<b>APPLICATION NO.</b>	<a href="#">P20/S2729/HH</a>
<b>APPLICATION TYPE</b>	HOUSEHOLDER
<b>REGISTERED</b>	27.7.2020
<b>PARISH</b>	THAME
<b>WARD MEMBERS</b>	Pieter-Paul Barker Kate Gregory David Bretherton
<b>APPLICANT</b>	Mr Lloyd Smith
<b>SITE</b>	44 Cedar Crescent, Thame, OX9 2AU
<b>PROPOSAL</b>	Variation of condition 2 (approved Plans) of application P19/S0998/HH (Single storey rear and side extension and alterations) -To allow for alterations to the approved scheme to facilitate provision of first floor accommodation within roof void (as amended by plan and additional information received 12 October 2020 providing floor level information and plans received 26 November 2020 reducing depth of side roof extension).
<b>OFFICER</b>	Victoria Clarke

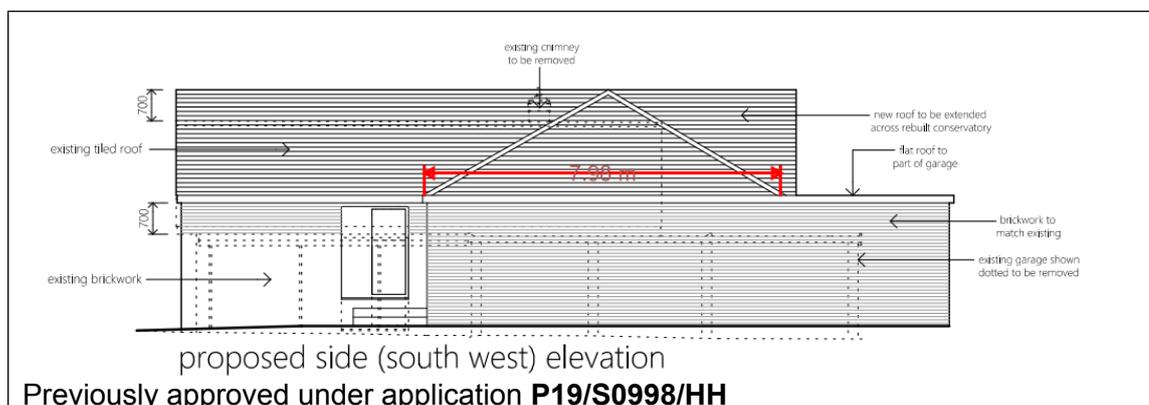
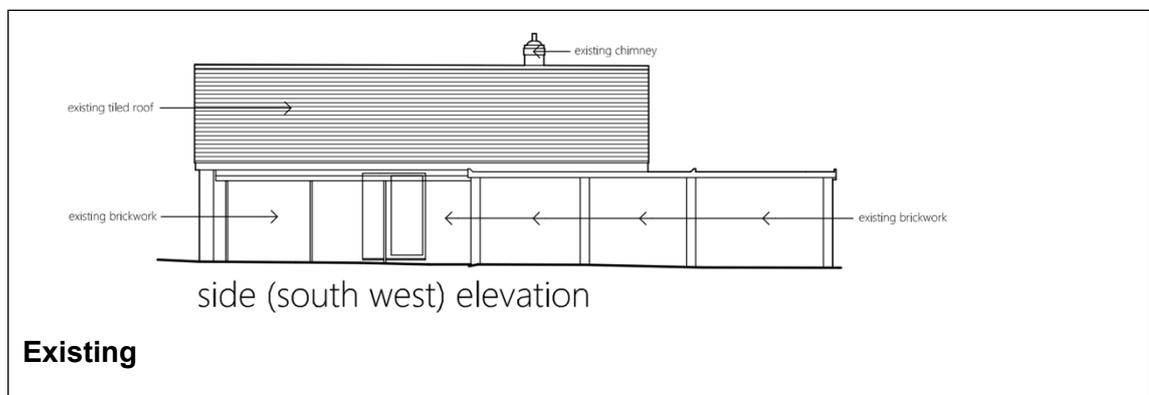
The design of the proposed development is almost identical in appearance to the previously approved application P19/S4651/HH with the exception being the proposed first floor roof extension to the south western side extending deeper, towards the rear of the plot. When viewed from the street, the front elevation would be unchanged compared to the previously approved scheme.

6.5 Officers consider the proposal enables the property to retain its appearance of a bungalow from the front. Rooflights would be visible but these are not uncommon on surrounding properties. A sufficient visual gap between the roofs of 44 and 42 Cedar Crescent would also be retained. Officers are satisfied the proposal would not be harmful to the character of the street and that the property would still relate well to the surrounding area.

6.9 A comparison of the existing, approved and proposed south western elevation is shown in the following plans:

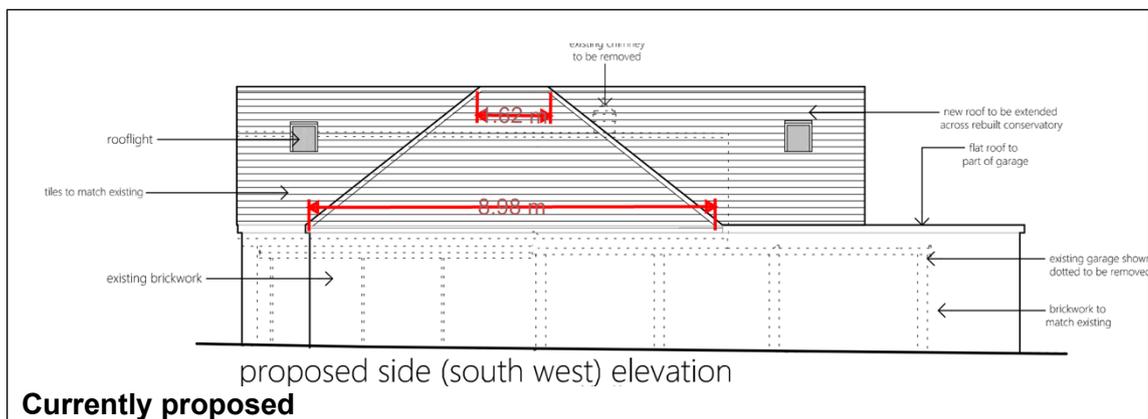
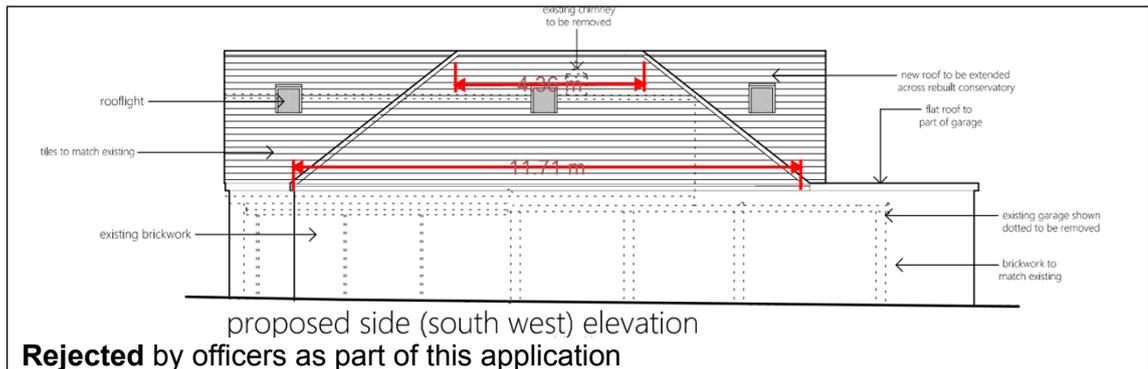
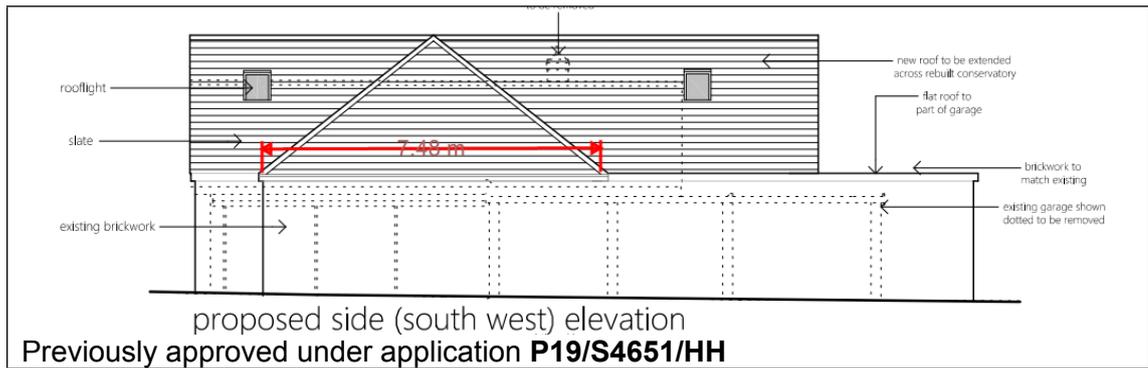
Concerns have been raised about the loss of light and outlook for neighbouring property 42 Cedar Crescent as a result of the proposed enlargement of the first floor footprint on the south-west elevation.

6.8 Plans were initially submitted with this application proposing a much deeper first floor extension with a footprint extending approximately 11.70 metres along the south western boundary. At the request of officers, amended plans have been submitted reducing this to just under 9 metres. Officers consider the amendment is sufficient to overcome our concerns about the impact on the neighbouring property at 42 Cedar Crescent.

- 6.10 The neighbouring property at 42 Cedar Crescent has three high level ground floor windows along the boundary with the application property. It is noted that one of these windows appears to serve an en suite and is not therefore a habitable room, and all three rooms appear to be served by windows or rooflights in addition to these high level windows.

- 6.11 The mass of the proposed roof would result in the loss of some light to two of these windows in particular, but due to the pitch of the proposed roof sloping away from the windows and low height of the eaves, officers are of the view that the reduction in light and outlook from the rooms in the neighbouring property would not be harmful and therefore is not sufficient reason to warrant refusing the application.
